Information note

N° 10403AERRA

Errata sheet V2.00 affecting products TC37x_AA

AURIX™ TC37x errata sheet

Figure 1 Message buffer transfer from Message RAM to OBF

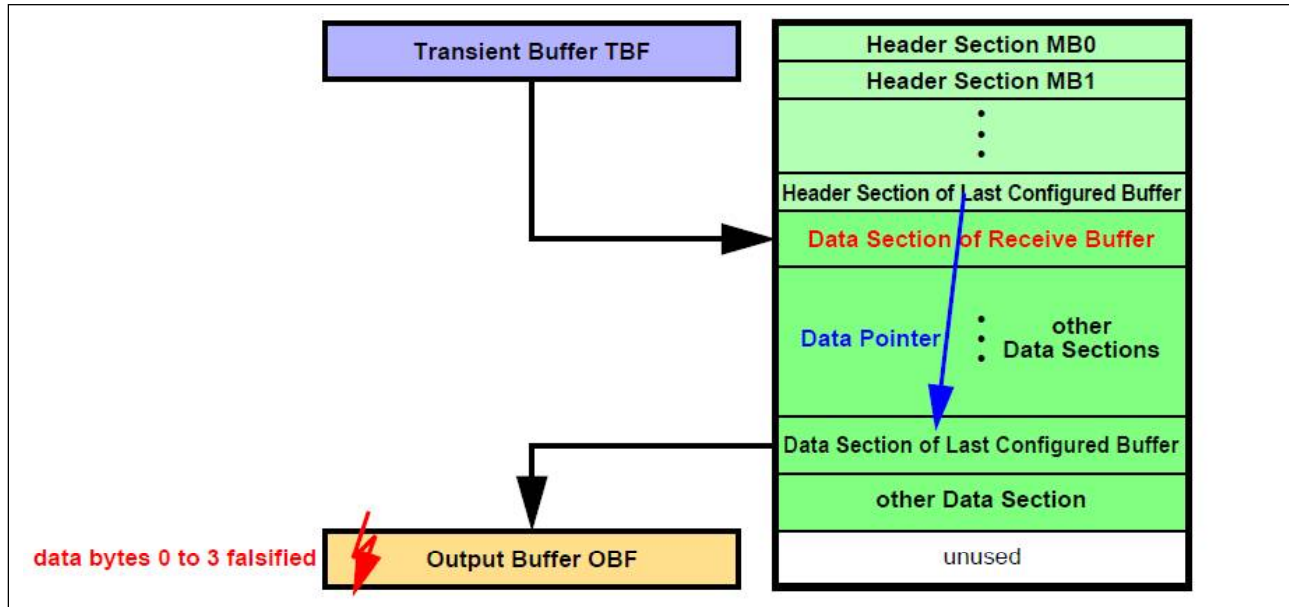
When the message buffer has its payload configured to maximum length (`PLC = 127`), the OBF word on address `00h` (payload data bytes 0 to 3) is overwritten with unexpected data at the end of the transfer.

Figure 2 Message buffer transfer from IBF to Message RAM

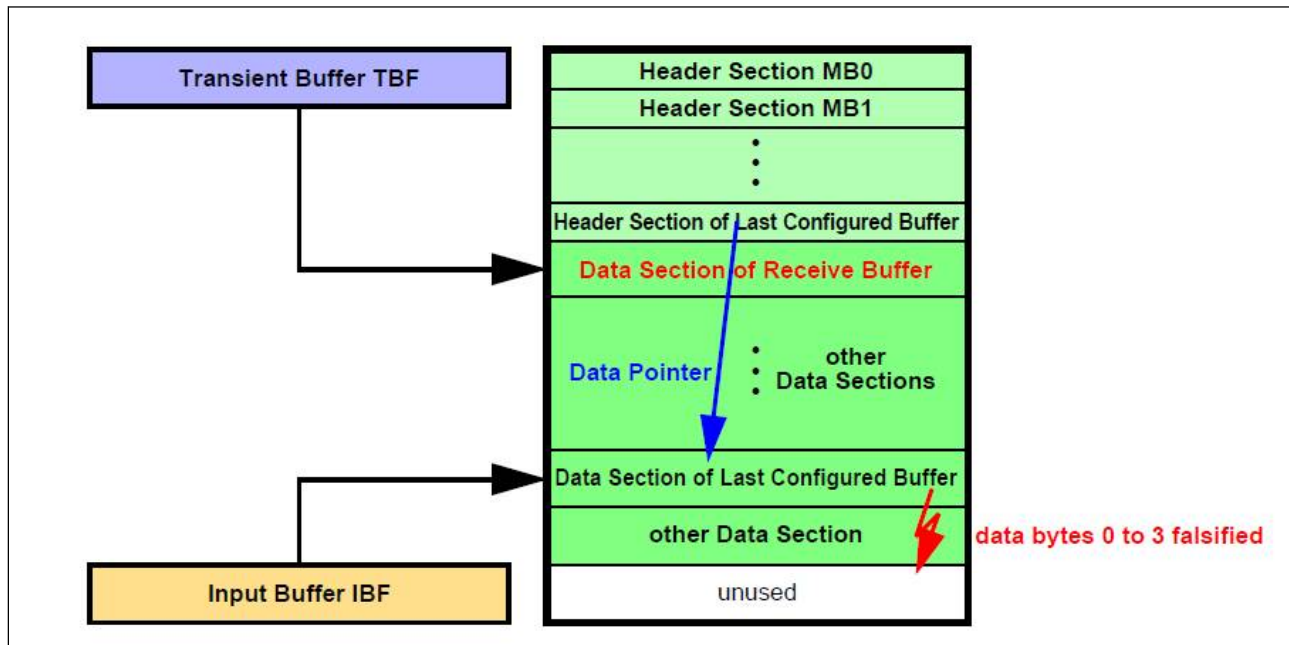
After the Data Section of the selected message buffer in the Message RAM has been written, one additional write access overwrites the following word in the Message RAM which might be the first word of the next Data Section.

- a) When a message is transferred from the Last Configured Buffer in the Message RAM to the OBF and PLC = 127 it may happen, that at the end of the transfer the OBF word on address 00h (payload data bytes 0 to 3) is overwritten with unexpected data (see [Figure 1](#))
- b) When a message is transferred from IBF to the Last Configured Buffer in the Message RAM, it may happen, that at the end of the transfer of the Data Section one additional write access overwrites the following word, which may be the first word of another message's Data Section in the Message RAM (see [Figure 2](#))

Figure 3 Message RAM configurations

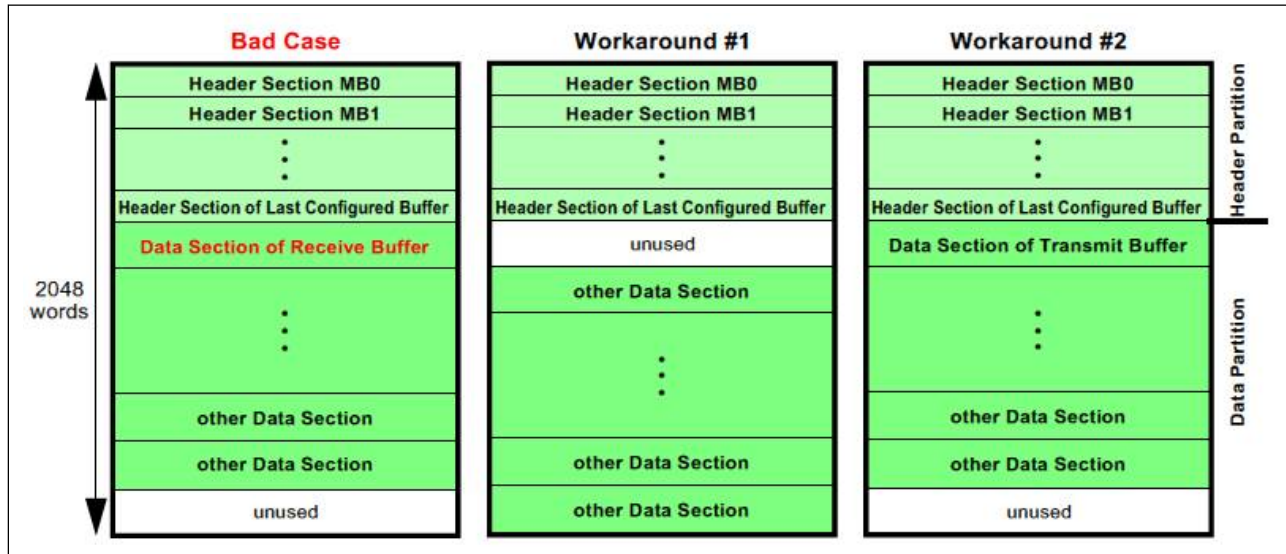
The erratum is limited to the case when (see [Figure 3](#) “Bad Case”):

Workaround 2

Ensure that the Data Section directly following the Header Partition is assigned to a transmit buffer.

Figure 6 Critical MCS AEI master scenario

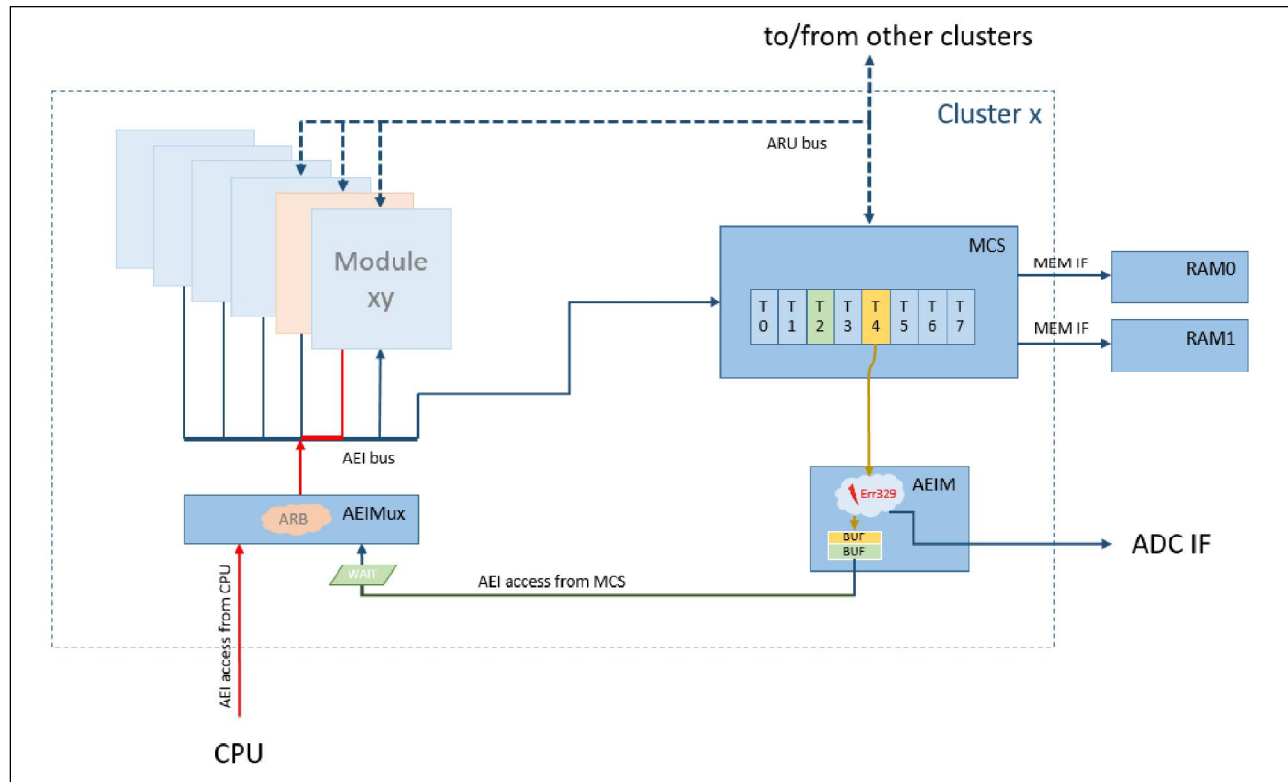
In [Figure 6](#), a potential risk for the occurrence of problem GTM_AI.329 is illustrated. Here the first buffer of the AEIM (green) is still waiting for the access to the AEI bus while a second AEI bus access from MCS arrives at the AEIM (yellow access path). Under certain, but for the user unpredictable timing conditions, this second AEI bus access arriving at the AEIM can trigger the misbehavior described in problem GTM_AI.329.

The workarounds described in the 'Workaround' section will ensure that not more than one AEIM buffer will be filled and therefore the occurrence of problem GTM_AI.329 is avoided. All workarounds have been tested and proven correct.

Figure 7 MCS token mechanism

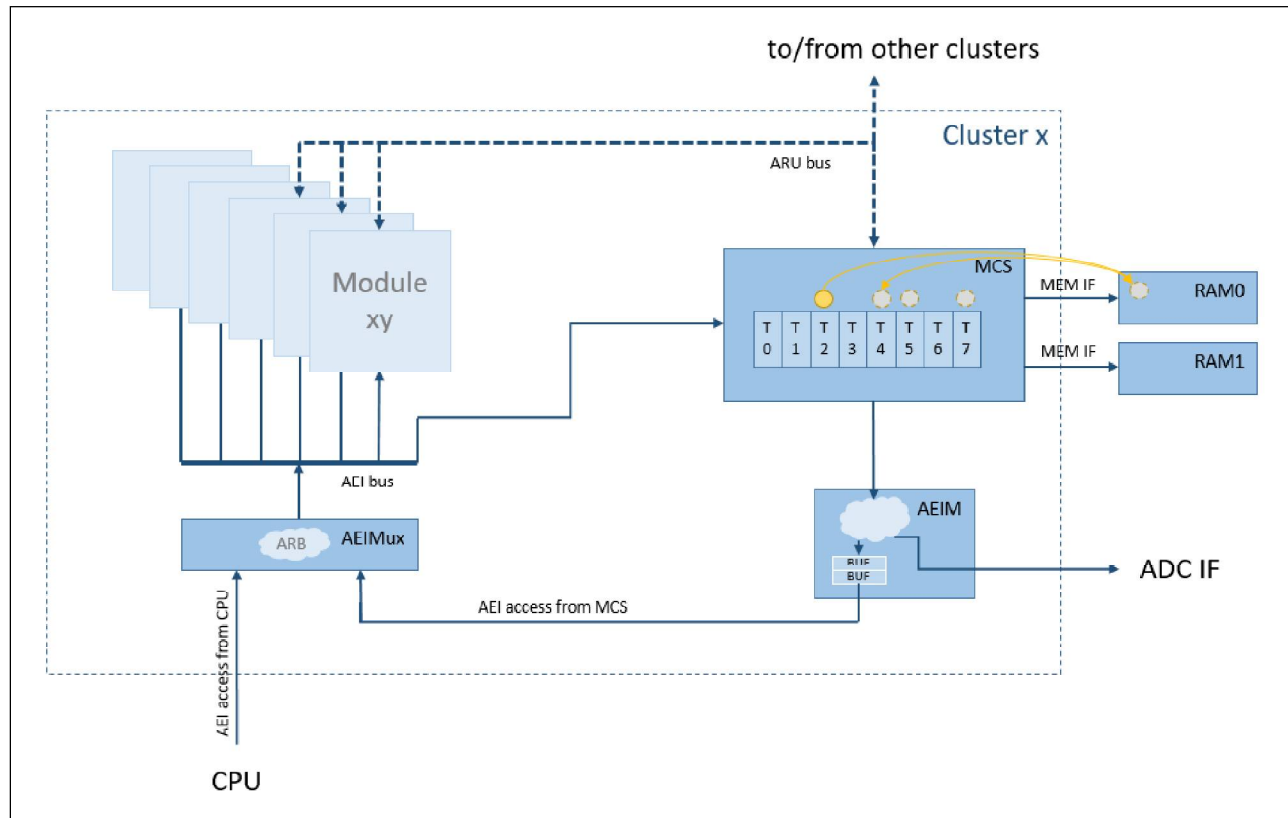
In case multiple MCS channels want to use the AEI master port for AEI or ADC communication, establish a mechanism that ensures that only one channel uses the AEI master at a time (e.g. exchange a token between channels or use trigger registers to hand over the AEI master port ownership between MCS channels).

An application note (AN020 – MCS Mutex implementation) describing a token exchange mechanism between MCS threads is available at Bosch. Such a token mechanism allows multiple MCS threads to safely access the AEI bus system by exchanging an AEI bus access token via MCS memory.

Figure 8 Interrupt Level vs. Pulse-Notify mode - Corner Case Example

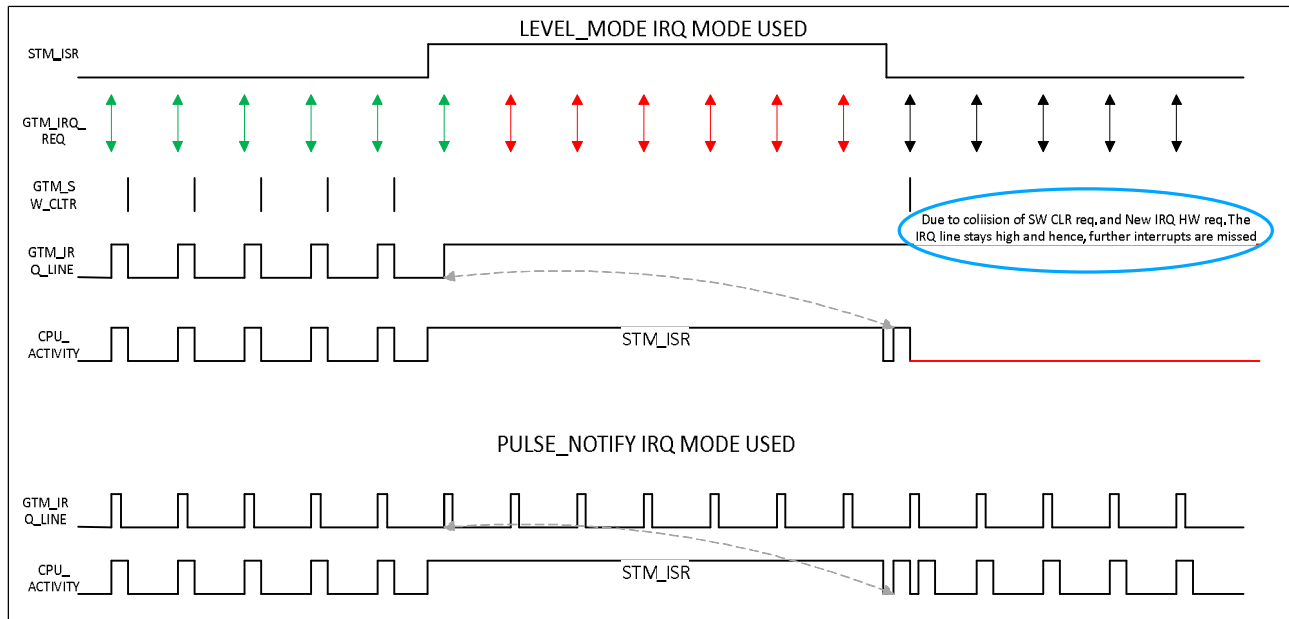
As described in the text below this figure, while using Level mode, if more internal “interrupt” events are generated (i.e. two TOM channels generating a CCU0 interrupt), just one interrupt signal is sent to the IR, and no more interrupts are triggered until the SW clears the GTM_IRQ_XXX line towards the IR.

Hence, in Level Mode, in some scenarios where another interrupt request is generated by GTM while the ISR handle also requests a SW clear, then, as the interrupt event is dominant over the clear event (for simultaneous interrupt and clear events), GTM_IRQ_XXX is not cleared and remains high. As a consequence, the IR observes no transition on GTM_IRQ_XX. Thus, any forthcoming interrupt events in this scenario are lost as there is no chance to release the CPU IRQ when a collision happens as shown in Figure below.

If Pulse-Notify mode is selected, every internal trigger will be forwarded to the IR, irrespective of the time of occurrence and the clear event, as the pulse-notify leads to set and reset of GTM_IRQ_XXX as compared to only setting of the GTM_IRQ_XXX line in Level mode.

Figure 9 Timing of LVDS TX interface command sending in relation to IRQ.IFCFS

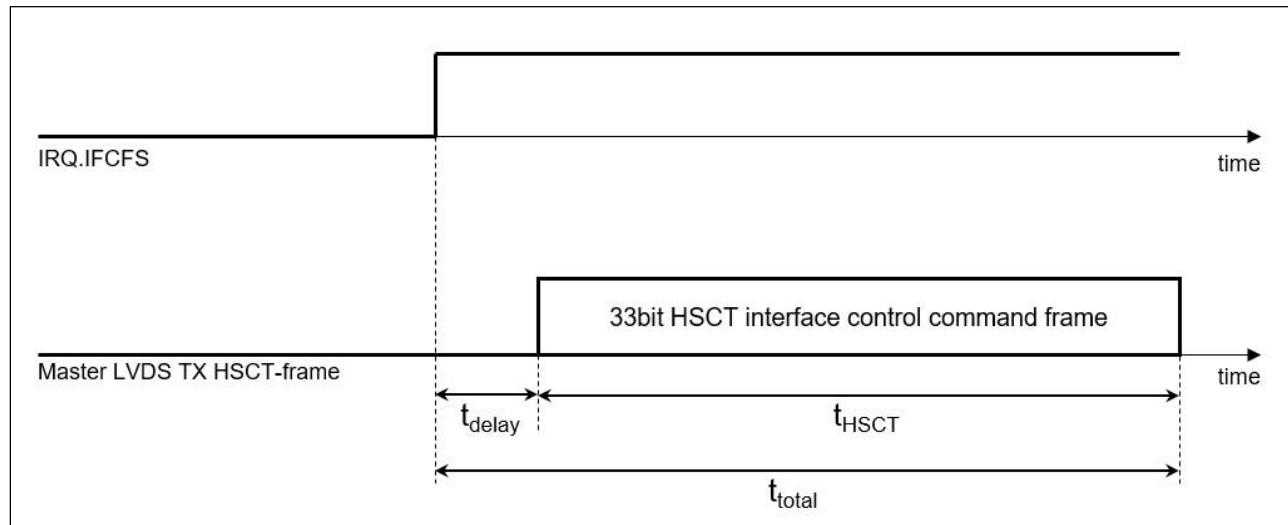
Instead the timing shown in the following figure applies.

Figure 10 Package Outlines LQFP-176 for TC37x

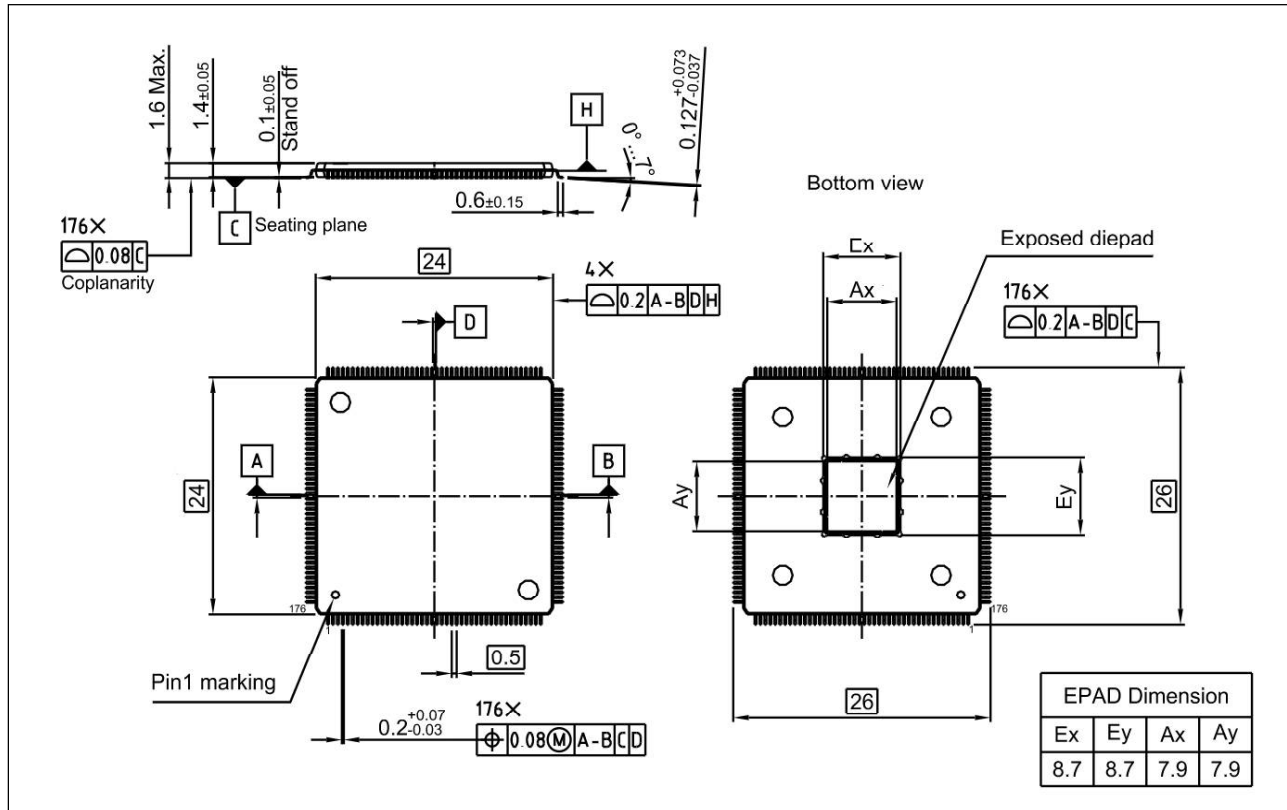
This information shall substitute the corresponding information in the TC37x AA-step Data Sheet V1.1.

Note: For the exposed diepad of the LQFP-176 package of the TC37x, structural corner protrusions have to be considered for purposes of system design and integration with a maximum boundary of 9.4 mm.

Figure 11 Positive overload on P-pad of a LVDS RX pin pair (both used as inputs)

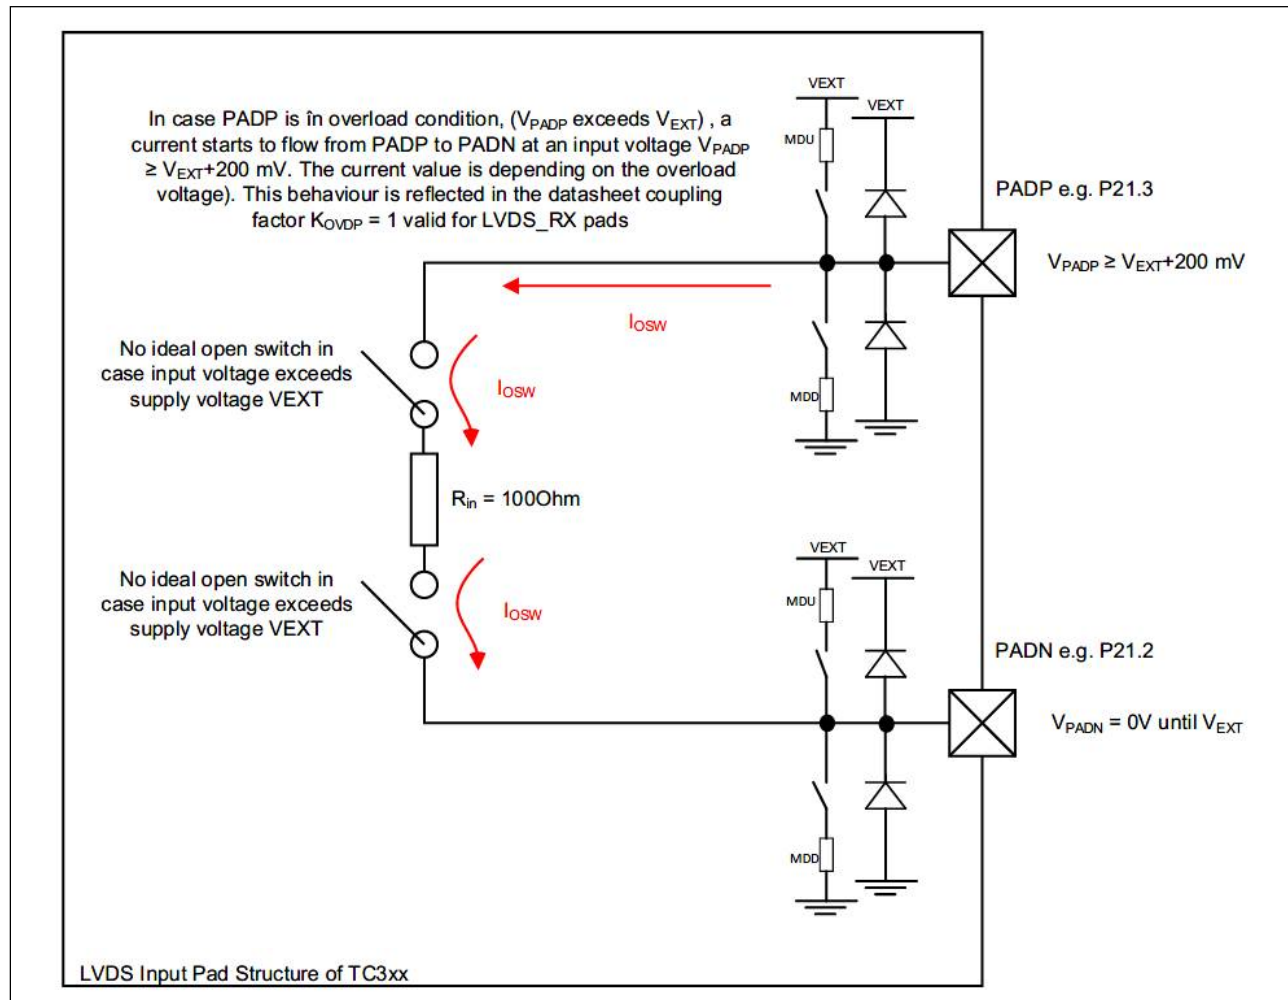
The overload current I_{OSW} through the non-ideal open switch significantly increases when $V_{PADP} \geq V_{EXT} + 200$ mV.

Note: In general, the effect will also occur if the N-pad is used as output, or for a negative overload condition on either the P-pad or the N-pad.
